CHANGE ORDER NO. 7

ADDITIONS AND ALTERATIONS TO HURRICANE DECK ELEMENTARY CAMDENTON R-III SCHOOL DISTRICT

ARCHITECT'S SUPPLEMENTAL

12a

Attachments: SD-C08 (3/2/2015)

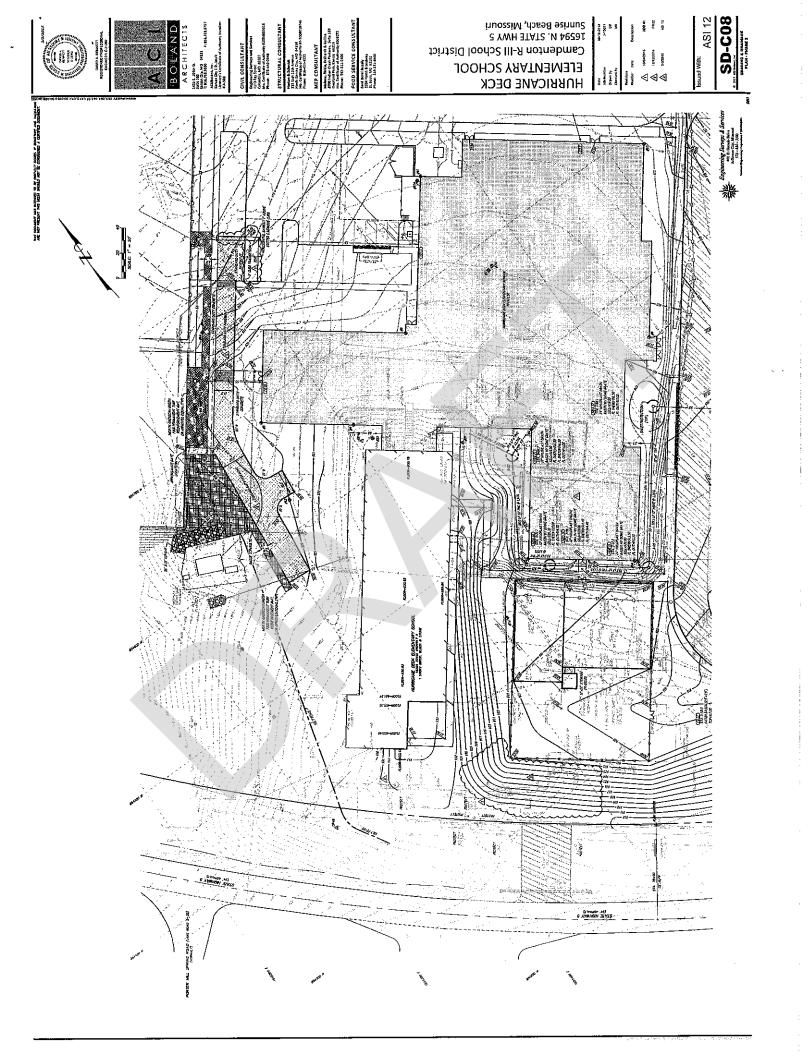
Description: Per email received 6/16/15 from Bales Construction, revise site plan as shown on SD-C08 (revised 3/2/15). Please note that erosion control for the immediate area around the revised grading shown on SD-C08, top soil placement, and sod will be performed by Owner.

Please notice I widened the curb cut connection another 5' to 35' in width. I checked truck access at this location and the 30' worked, but adding the extra 5' will give better buffer for trucks.
